**PURPOSE:** To announce updated termination kits for non-condensing water heaters effective 7/27/2023.

Applicable Products: All RE/REP Series Non-condensing Tankless Water Heaters

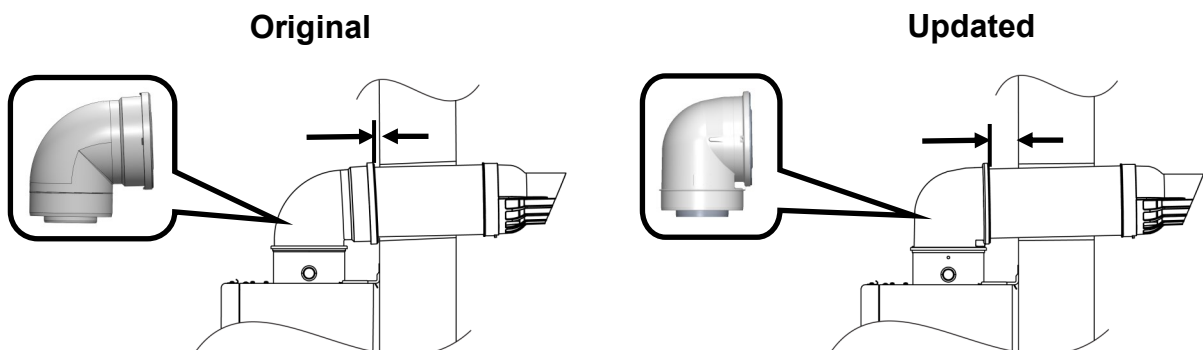
**1** The elbow included with the termination kit has been updated to provide additional clearance between the wall and the socket side of the elbow. This additional clearance will improve accessibility during installation.

**2** Termination and wall plate color have been updated from black to grey.
